# UNITED STATES PATENT AND TRADEMARK OFFICE

10/786,275

<b>Office Action Summary</b>	Application No. 10/786,275	Applicant(s) MARQUARDT ET AL.	
	Examiner Michael P. Stafira	Art Unit 2877

## DETAILED ACTION

FIG. 8

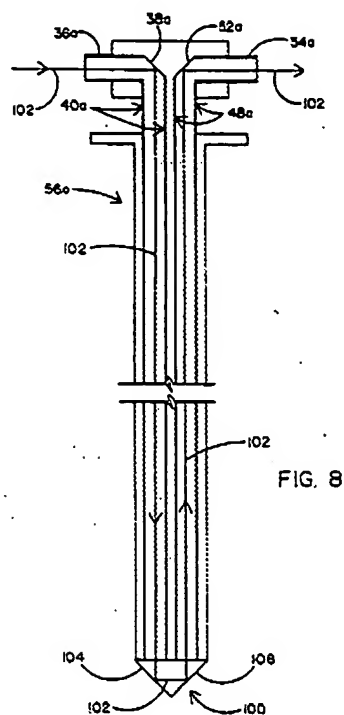
Doyle ('551) discloses an immersion probe housing tube (Fig. 9, Ref. 110) having a first opening at a first end and a second opening at a second end (See Fig. 8); and a gasket (Fig. 9, Ref. 116) disposed inside said immersion probe housing tube (Fig. 9, Ref. 110) positioned between said immersion probe housing tube (Fig. 9, Ref. 11) and said the lens (Fig. 9, Ref. 112)(Col. 10, lines 62-64) at said first opening (See Fig. 9), wherein said gasket (Fig. 9, Ref. 116) is on top of and in contact with the lens (Fig. 9, ref. 112).

FIG. 9

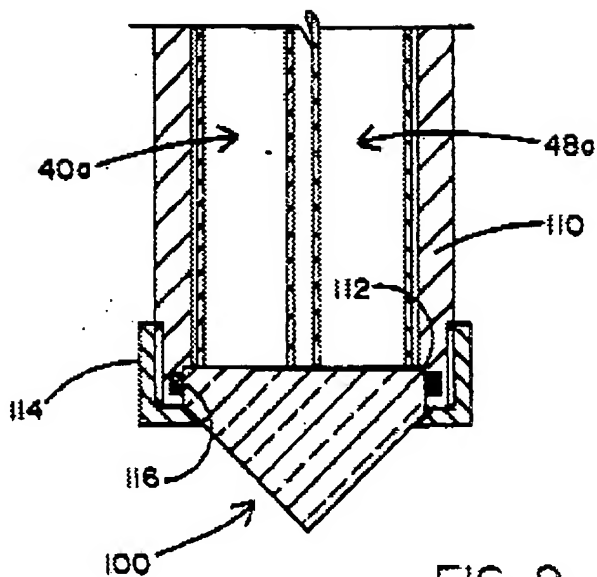
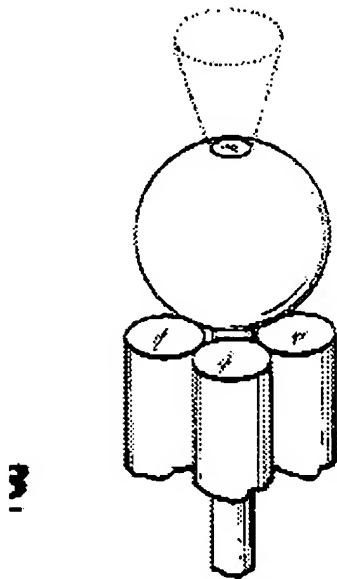
Doyle ('551) substantially teaches the claimed invention except that it does not show a spherical lens disposed in the probe at a first opening. Wach et al. ('234) shows that it is known to provide a spherical lens (Fig. 53b) disposed at the end of a probe for an apparatus probe for measuring spectroscopy. It would have been obvious to combine the device of Doyle ('551) with the spherical lens of Wach et al. ('234) for the purpose of providing a focal length equal to the distance from its surface to the axis, therefore increasing the sensitivity of the measuring probe.

The reference of Doyle ('551) further discloses the interior surface of said immersion probe housing tube at said first opening of said immersion probe housing tube is chosen from the group consisting of a round (See Fig. 9).
